Television Service Tips

Volume XIX
Issue 1
March 15, 1968

Important Information for your Service Department

Prepared and Distributed by RCA Sales Corporation, Product Performance
600 N. Sherman Drive, Indianapolis, Indiana 46201

"Safety"-Back Retaining Nut
Models—AJ 095, 153, 157—Chassis KCS 158

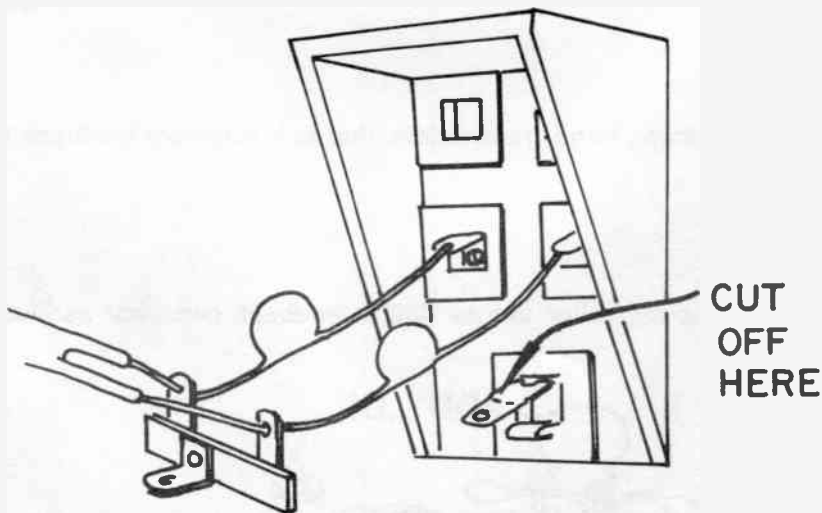
In instruments using the KCS 158 chassis, a metal screw is attached to a "tinnerman" nut on the antenna terminal board—used to help secure the rear cover. This "tinnerman" clip has a spade-type extension used in some instruments for antenna connections. However, in the KCS 158 instruments, the spade is **not** used.

Inasmuch as this spade is not used, it is recommended that when this chassis is serviced the spade be cut off. This would eliminate any possibility of a service man redressing the antenna capristor lead, and in doing so bring the lead in contact with the spade which would cause the rear mounting screw to become hot and create a possible shock hazard.

Manufacturing specification regarding the physical orientation of the capristor leads, with respect to the spade clip, provide sufficient clearance to avoid contact between the leads and the lug. However, a technician could exert some "extra" bending force to actually mis-dress and "short" the leads to the lug.

Current and future production instruments include a clip without this spade lug.

Please instruct service technicians in your area to **CUT OFF THE EXCESS LUG ANYTIME THE KCS 158 CHASSIS SERIES** is serviced, as illustrated below. The lead dress of the capristors should also be checked.

Low or Intermittent Sound Output.
CTC 21, 25, 30

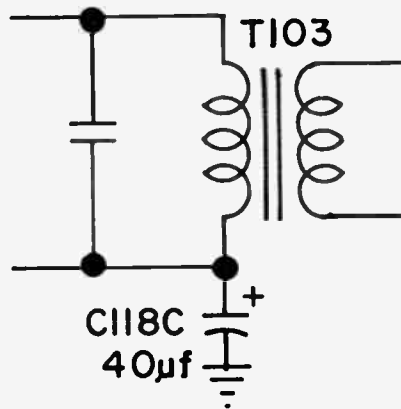
Some field reports indicate low or intermittent sound output may develop in the above listed chassis. Adjusting volume control up to "high" position **may** or **may not** cause normal operation to resume.

This condition may be caused by an intermittent open C206 (500 mfd. 15V) capacitor in the emitter circuit of the audio output transistor.

Some capacitors used in this circuit application have lead connections to the body of the capacitor which are "riveted." The open develops at the "rivet" connection causing low or intermittent sound. This capacitor should be **replaced, not repaired** and the replacement should be of a welded connection type. By ordering stock number 119608 you will get the correct capacitor.

In addition to above capacitor C118C across B+ to output transformer T103 should be examined for leakage or open condition. Replace with RCA stock number 119591 or equivalent.

Intermittent Oscillator Operation
CRK 9, 10, 11 Hand Transmitter

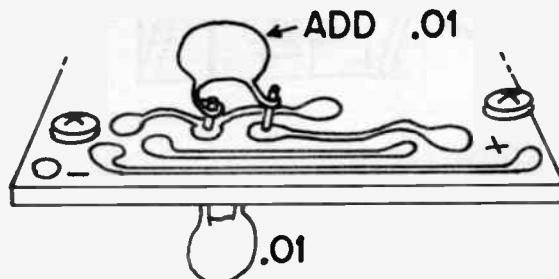
Intermittent operation may occur in these hand transmitters, due to insufficient feedback in the base circuit of the oscillator.

Add an additional .01µf ceramic capacitor across C2001 feedback capacitor as illustrated.

CTC 28, 30 Chassis Layout

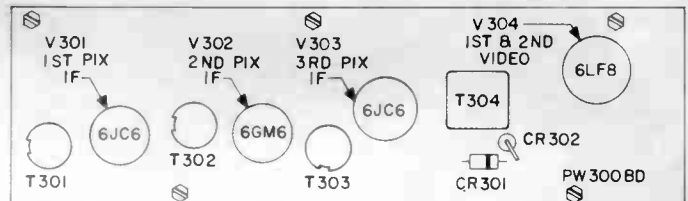
In the chassis layout of Service Data 1967 No. T16 and 1967 No. T18, the top view illustration on top of page 8 of both data, PW 300 Pix-Video board should be as shown in the illustration at the right.
